CLASS I SERVICE INSTRUCTIONS

No. 0638-240, Rev. I
ATA Code 28-00

SUBJECT: POWER PLANT - INSPECTION OF PLUMBING FITTINGS AT THE FIREWALL

SYNOPSIS OF CHANGE: EFFECTIVITY is expanded, MATERIAL section is corrected, warranty date is extended for some airplanes, and COMPLIANCE and PUBLICATIONS AFFECTED are rewritten in new format.

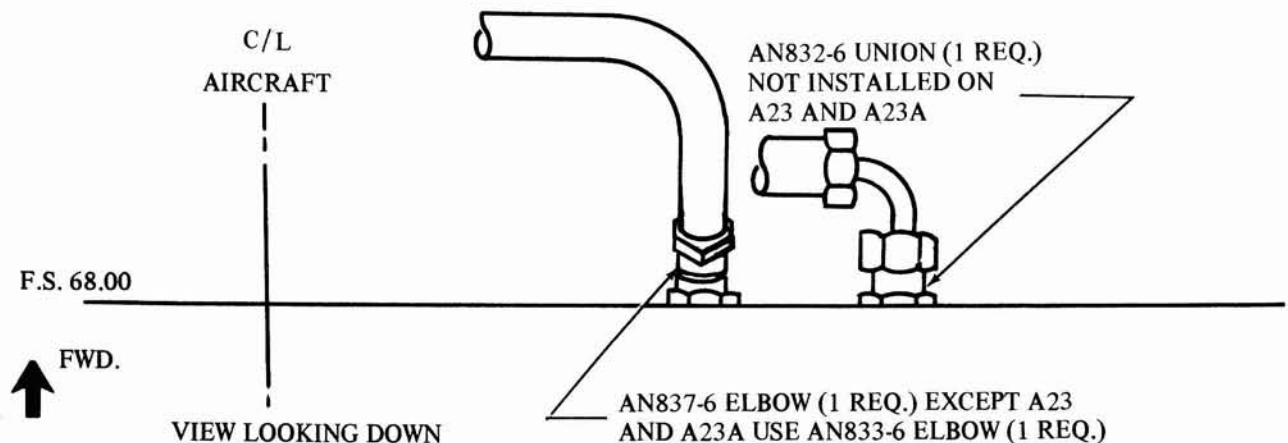
1. Remove the engine cowling if not already removed and inspect the firewall fuel line union and elbow shown in the illustration and if necessary, replace them with an AN832-6 union and AN837-6 elbow. An AN960-916 washer must be installed between the union and the firewall.
